DESC N96 APARTMENTS

DESIGN RECOMMENDATION REVIEW MEETING

937 N 96TH STREET
SEATTLE, WA 98144

SDCI PROJECT #3025501
RECOMMENDATION MEETING:
MAY 22, 2017

EDG MASSING OPTIONS

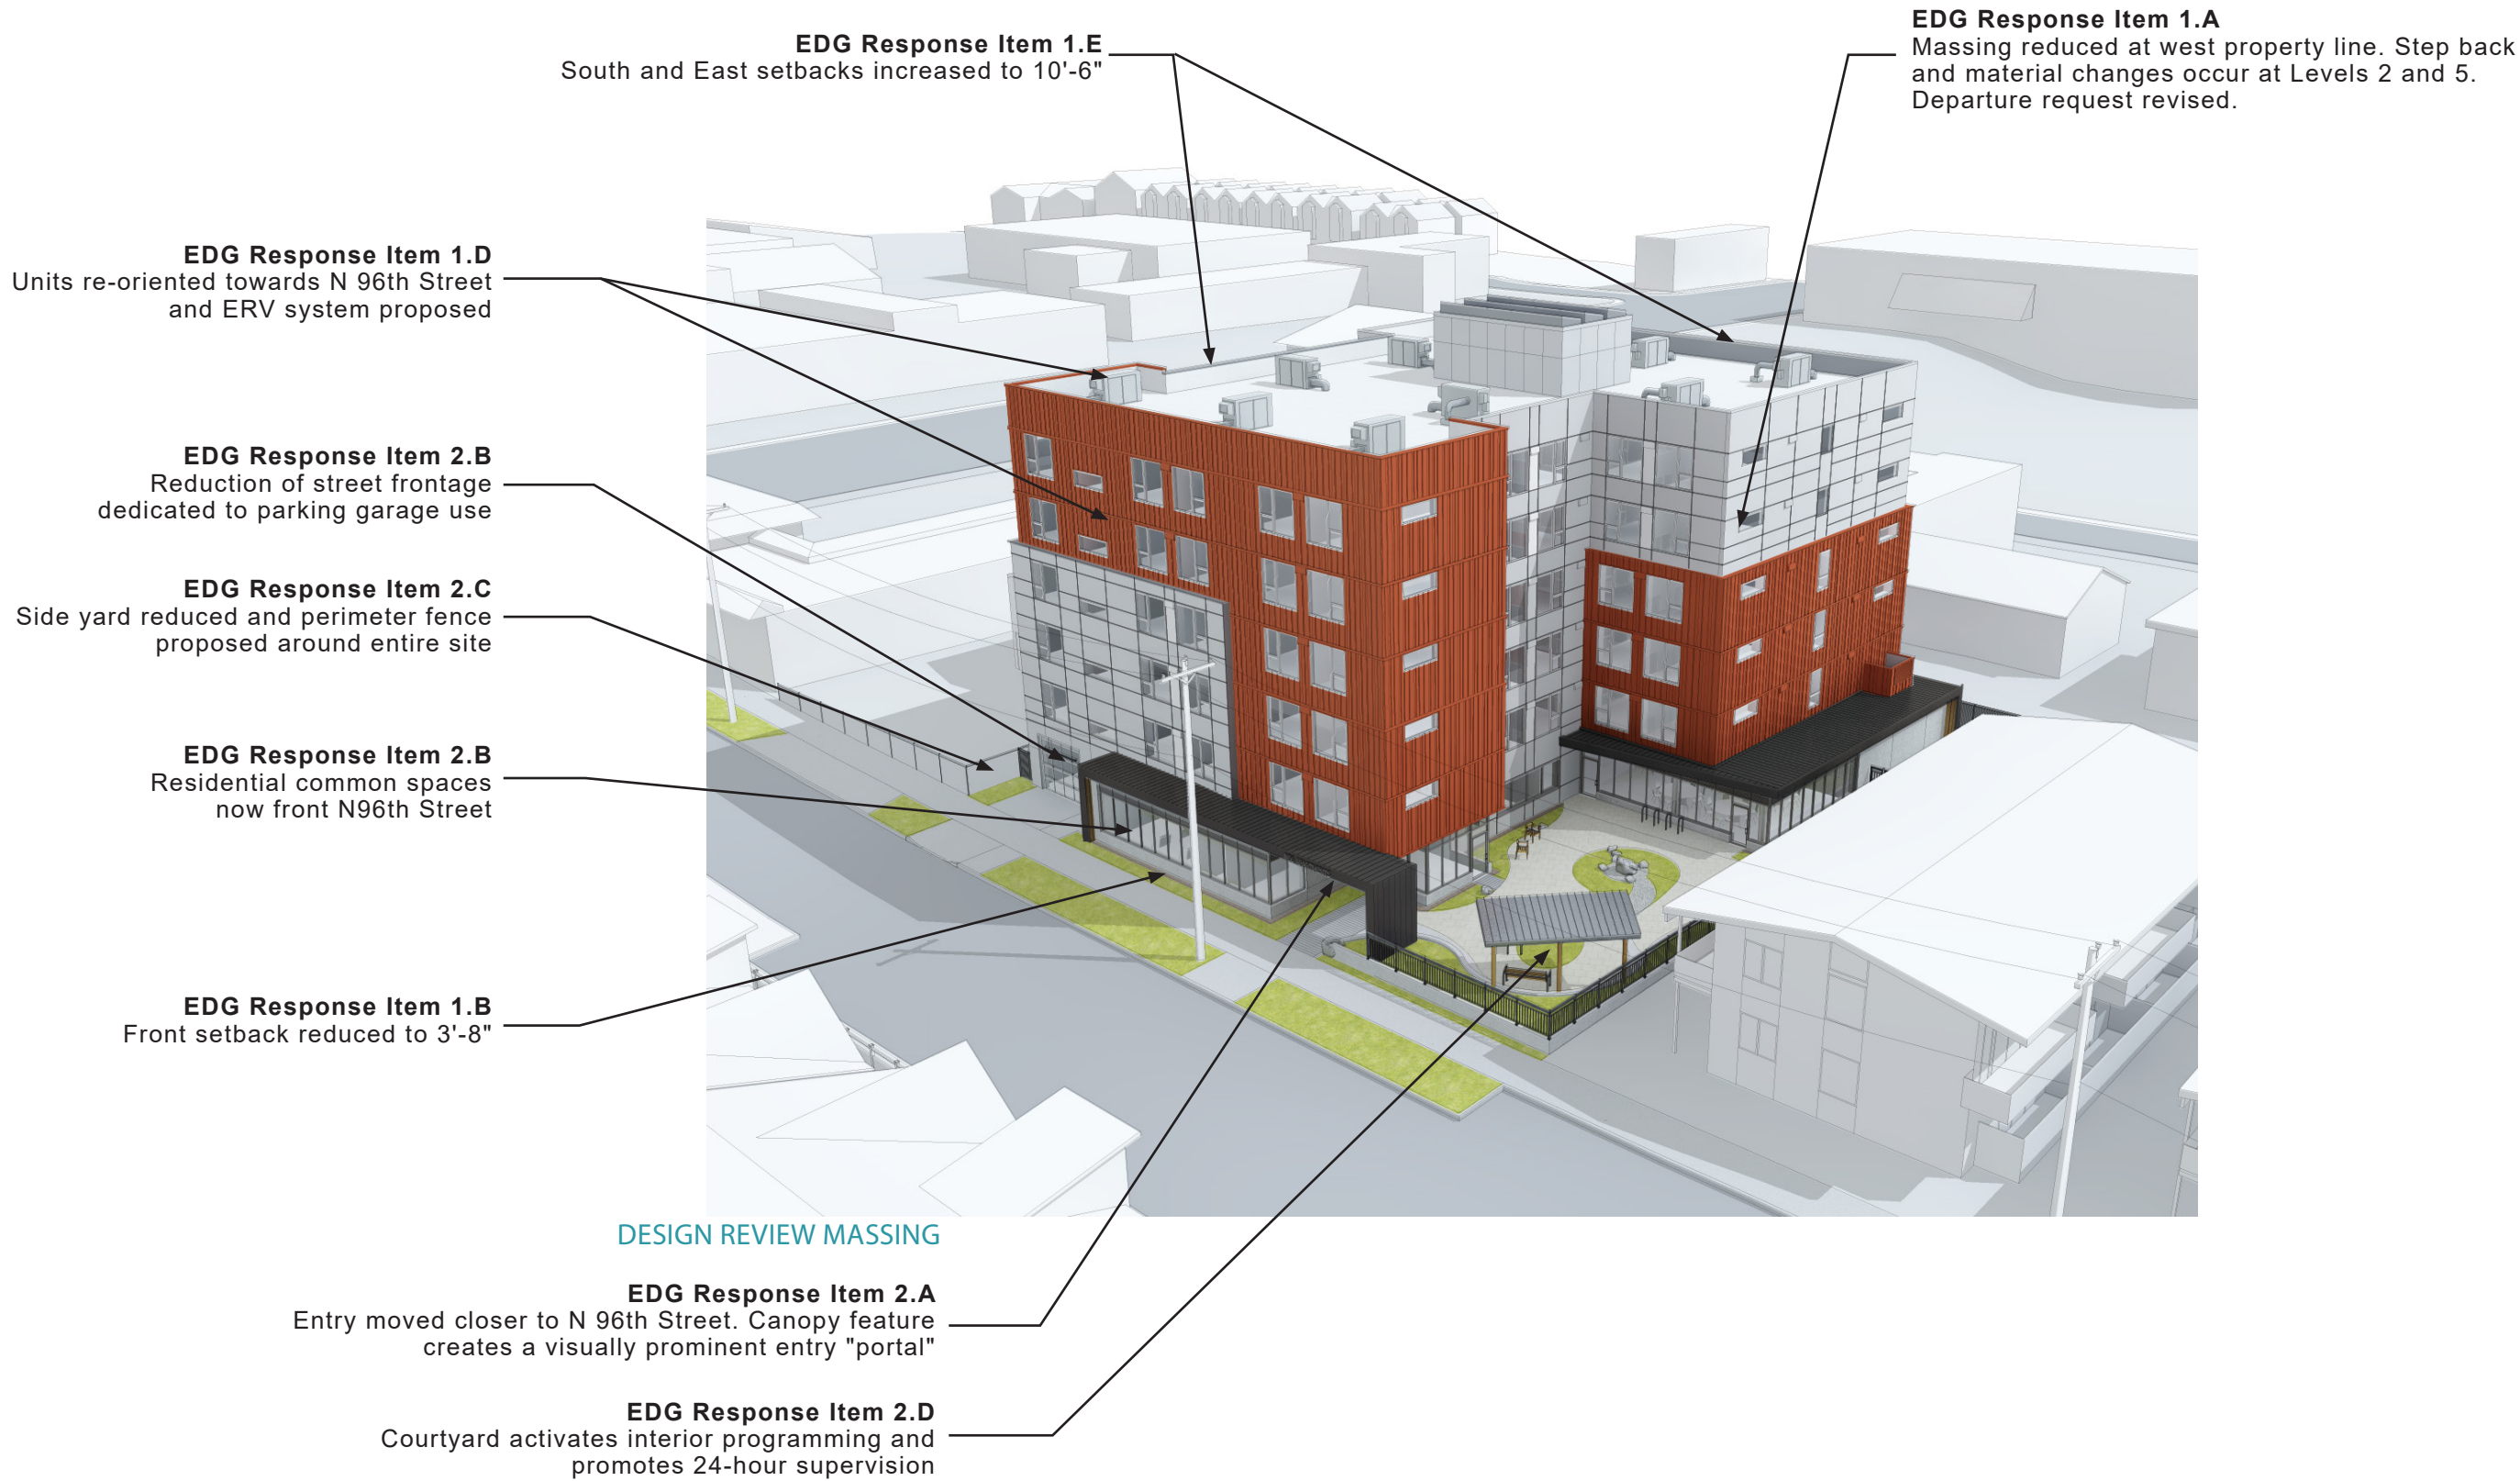
THE BOARD DID NOT STATE A SPECIFIC PREFERENCE FOR ONE OF THE PROPOSED MASSING OPTIONS, RATHER THEY DISCUSSED THE MERITS ASSOCIATED WITH EACH OPTION AND AGREED A HYBRID OF OPTIONS 2 AND 3 WOULD BE MOST SUCCESSFUL.

A. The Board was in support of the L-shaped massing options as it is an effective zone transition, however, the Board did not support the rationale for the requested departure which would reduce the side setback. It is unclear how the requested departure results in a design that better meets the intent of the guidelines and promotes respect for adjacent sites. (CS2-D-3, CS2-D-4)

- The building has been reconfigured to provide a better transition to the adjacent residential apartments to the west. The large massing transition shown at EDG now occurs at level 2 (CS2-D-3), reducing the departure request. A smaller step back occurs at level 5 in conjunction with a material transition to further break up the bulk of the building and respond to the scale and proportions of adjacent structures (CS2-D-4). Refer to the departure request on page 26 for additional information on how the departure better meets the intent of the design guidelines.

Item 2-F: Trash Pick-up Diagram

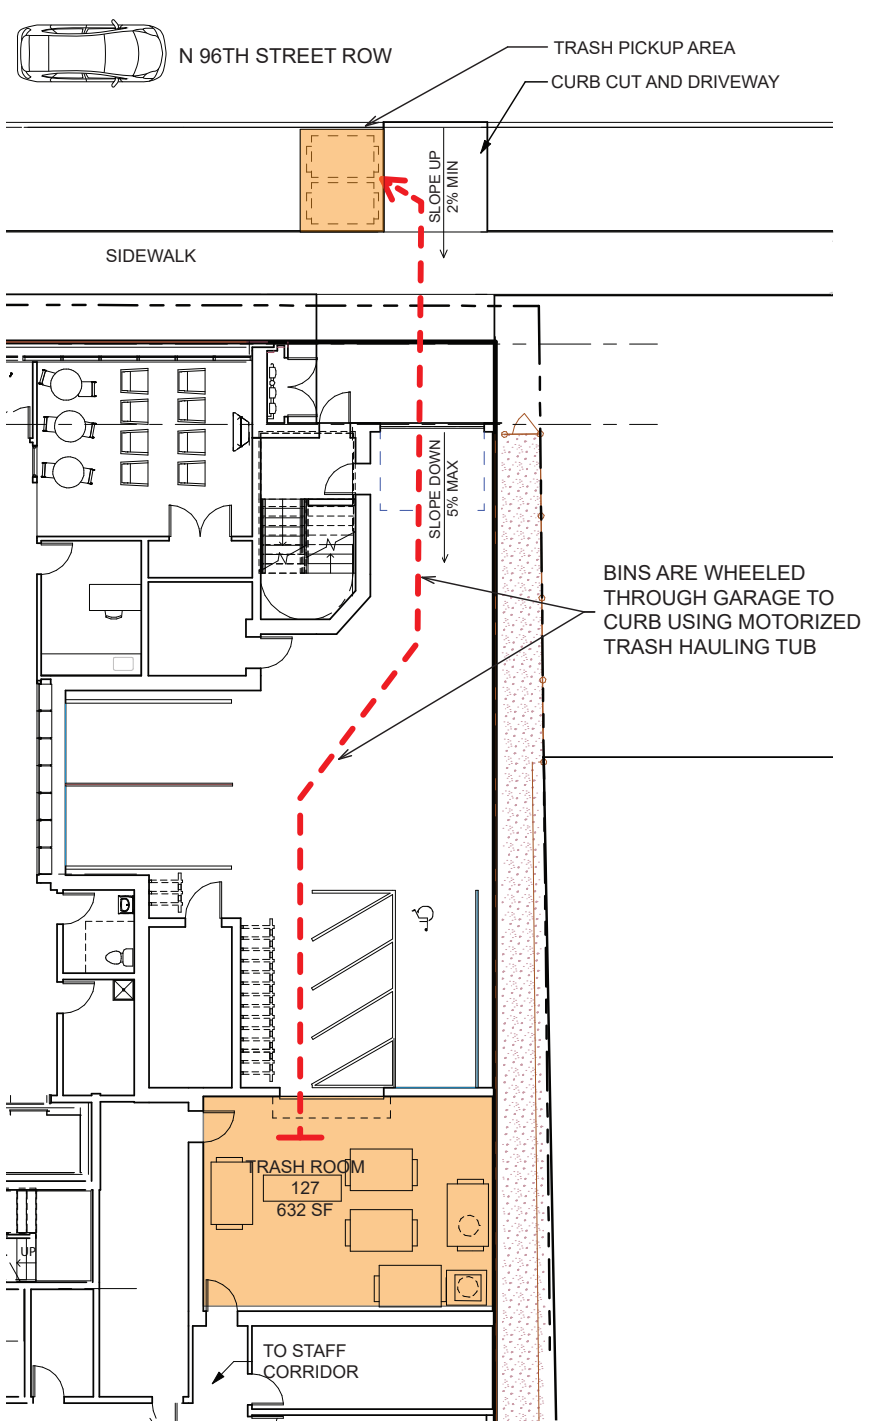
F. The Board requested further study of the trash and utility room locations. The Board suggested these services be located closer to the street to provide accessibility and minimize side yard spaces which may foster unwanted congregation. The reconfiguration of trash and utility rooms should be considered with any changes to the proposed parking garage. (DC1-B-1)

- The current scheme fences and reduces the size of the east side yard to alleviate safety concerns. The trash and utility rooms are accessed through the garage to limit the street frontage occupied by service and utility spaces.
- Building staff will use a motorized cart to tow the dumpsters through the parking garage and park them on the dedicated concrete pad adjacent to the curb cut along N 96th St. After trash pickup, the dumpsters will be towed back to the trash room. See adjacent Trash Pick-up Diagram
